SUNSHINE COAST REGIONAL DISTRICT

Question and Answers # 3

Request for Proposal No. 2536503

Watermain Replacement North Pender Harbour

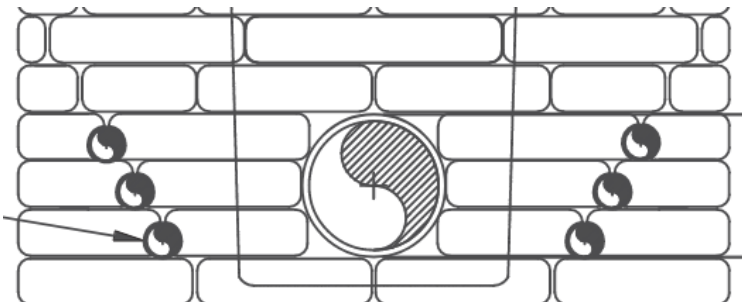
Question: Can prefilled concrete bags be used in lieu of the 16x G8 "Pipe anchor blocks" in section #1. In the past we have used this this method, staggering the bags so they lap. This would be a more cost effective option. See snip for a reference below.

Answer: Please bid as per the issued drawings and specifications. Any proposed alternatives, such as the use of prefilled concrete bags in lieu of the specified G8 pipe anchor blocks, may be submitted in Schedule 9 – Alternatives.
